**DEVIATION REQUEST
AND DECISION FORM**

Project Name : Prairie Heights Elementary School Expansion
 Schedule No.(s) : 5728004015
 Legal Description : LOT 110 MIDWAY RANCHES FIL NO 7 TOG WITH THAT POR OF VACATED INDIAN VILLAGE HEIGHTS

A deviation from the standards of or in Section **Chapter 2, Paragraph 2.4.1** of the Engineering Criteria Manual (ECM) is requested.

SHEET
C101
OF _ SHEETS

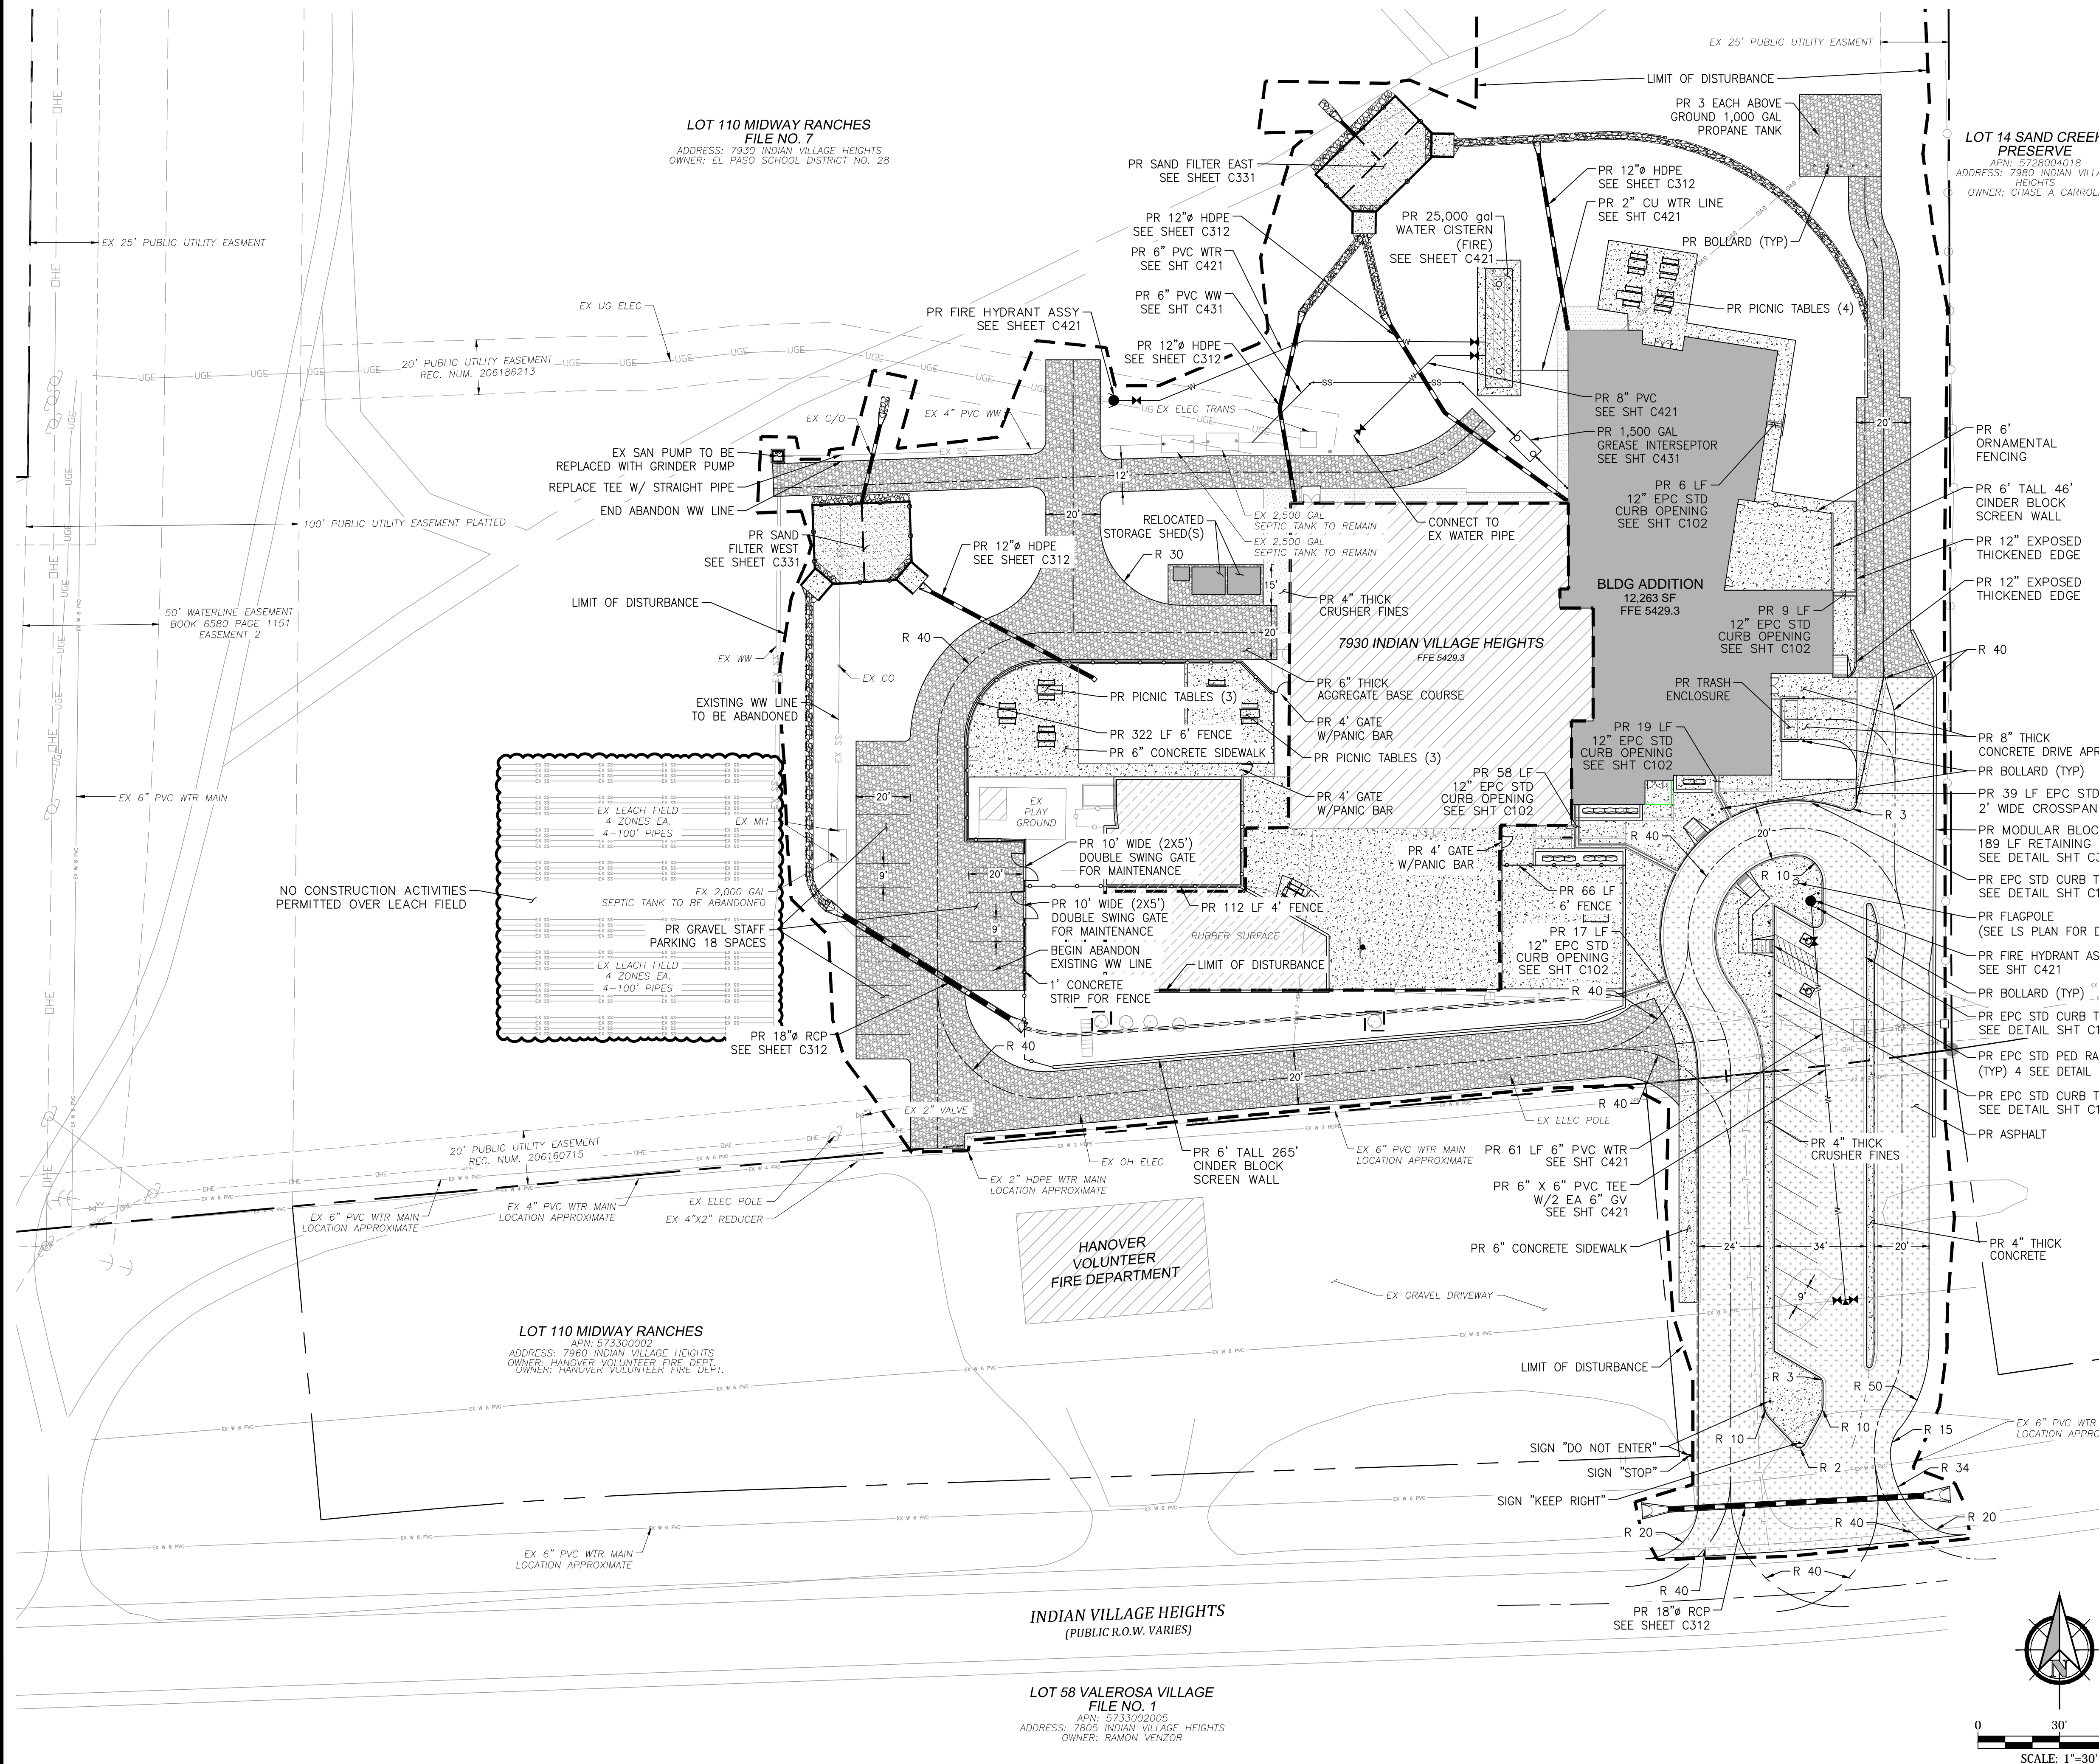
We are requesting a 71' wide driveway (118' measured at the end of the PCR's at the edge of the road.) The property frontage is too narrow (119.55') for two separate driveways. Additional width is required for the layout including the bus turning radii and raised median.

A raised median is provided to separate the in and the out direction with signage indicating "DO NOT ENTER" and "KEEP RIGHT" in accordance with MUTCD.

The project site has limited frontage along Indian Village Heights of approximately 119.55 feet. This frontage is insufficient to provide two separate driveways while maintaining required spacing, turning radii for school buses, and safe internal circulation. The proposed wider combined access with a raised median provides a functional equivalent to separate ingress/egress movements while fitting within the constrained site geometry. The design maintains clear channelization and does not compromise emergency access or pedestrian safety.
